Attachment A: MMD Technical Comments

No Agua Mine Revision 23-1

Permit No. TA005RE

Name of Operator: Imerys Perlite USA Inc. **Permit Update:** 5-year Closeout Plan Revision 23-1

No Agua
Ephemeral Streams
Figure 6

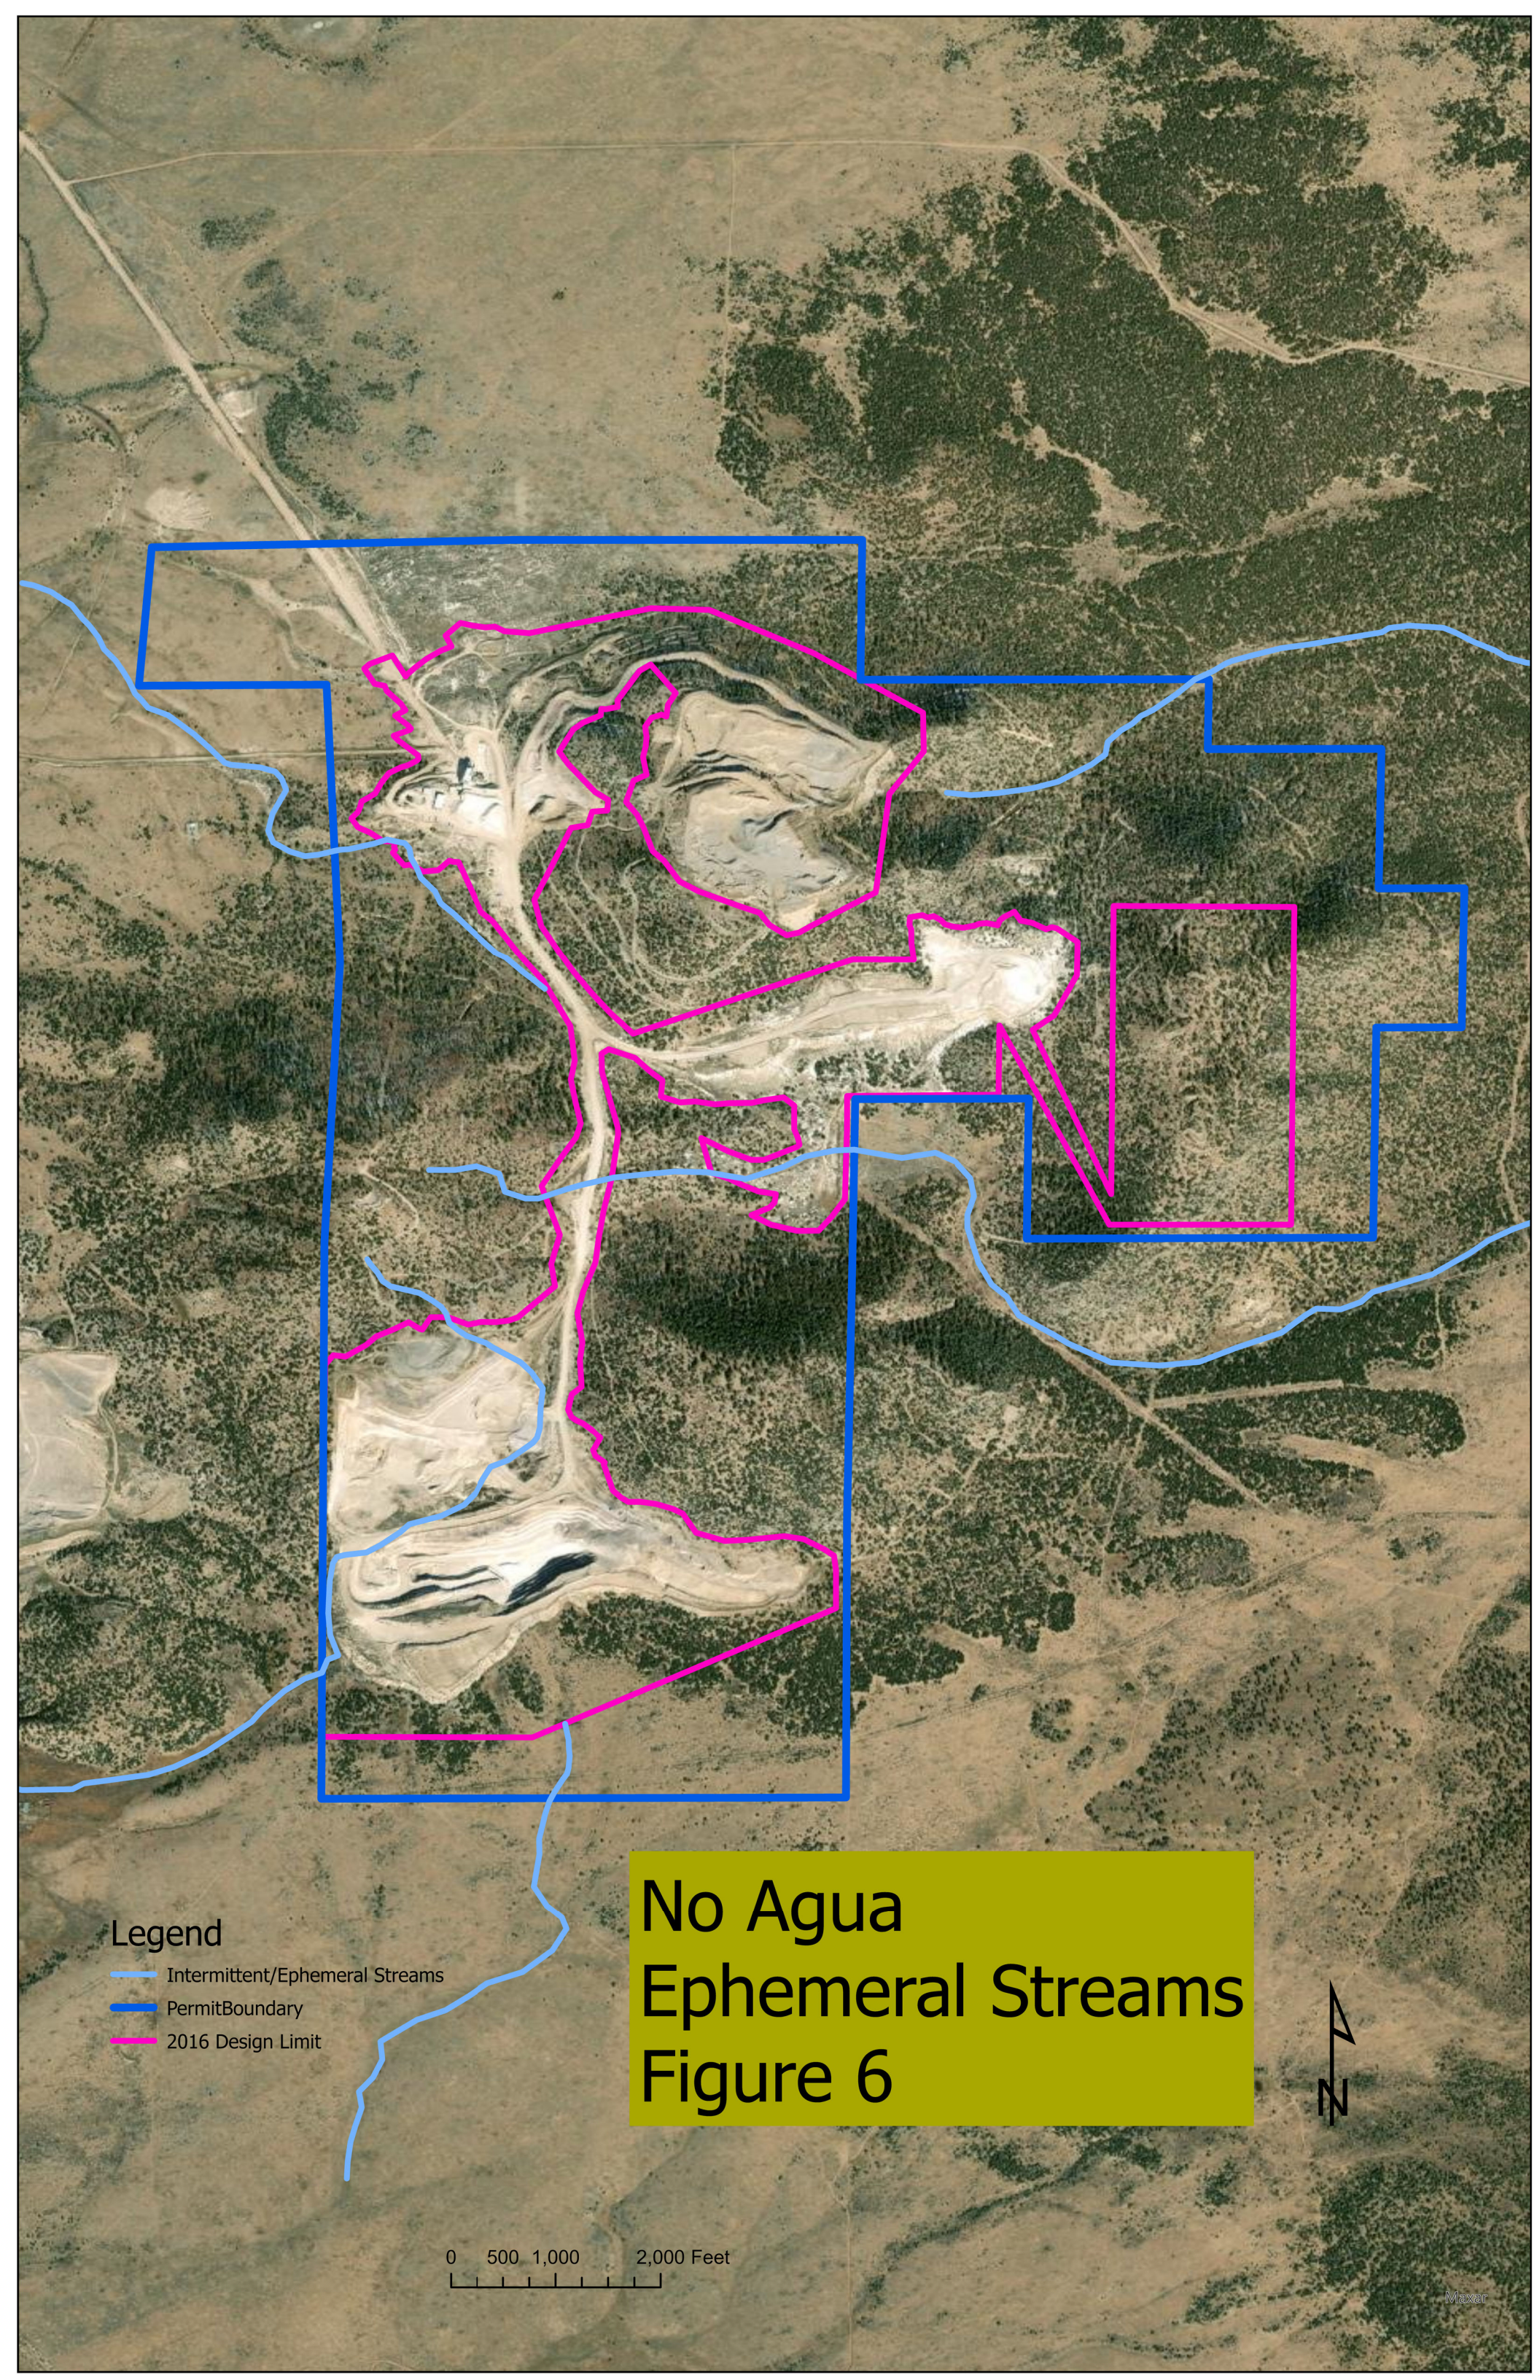
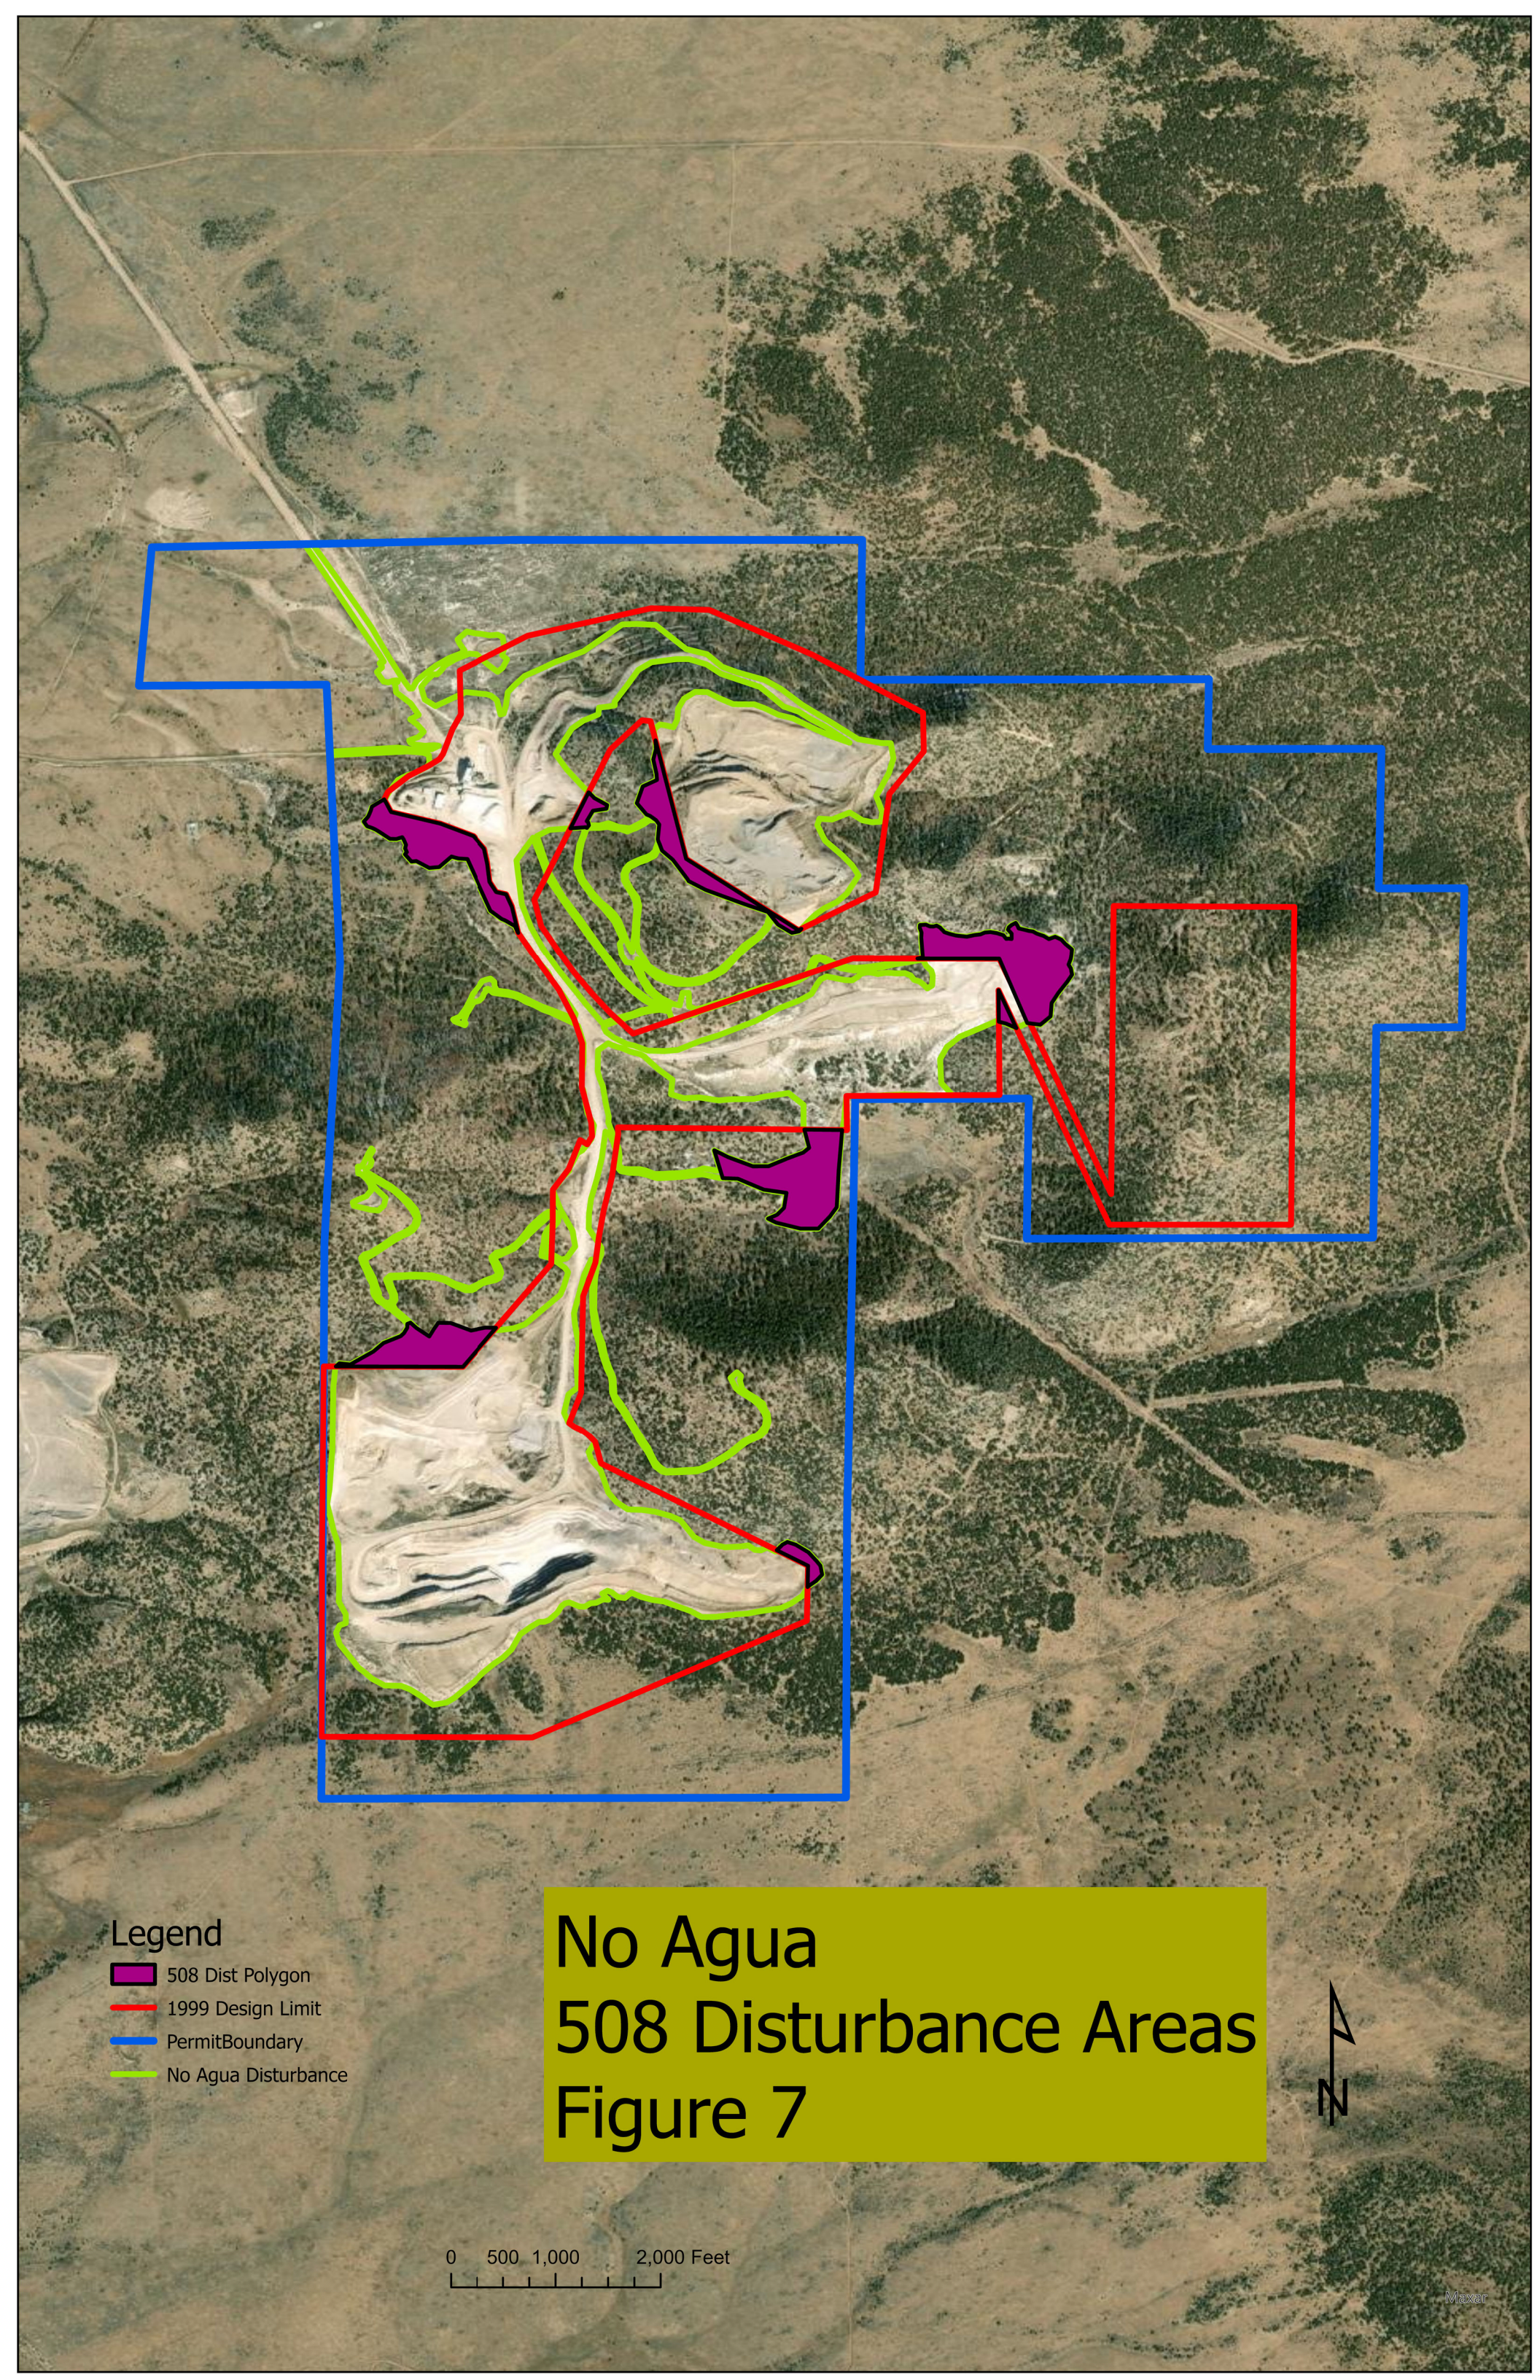
4. Section 2.10 Hydrology. Please include a map with the locations of perennial, intermittent, and ephemeral streams within the permit area, and identify and label the four catch basins described in this section. *See also, NMED Surface Water Quality Bureau comment #3.*

Please see Figure 6.
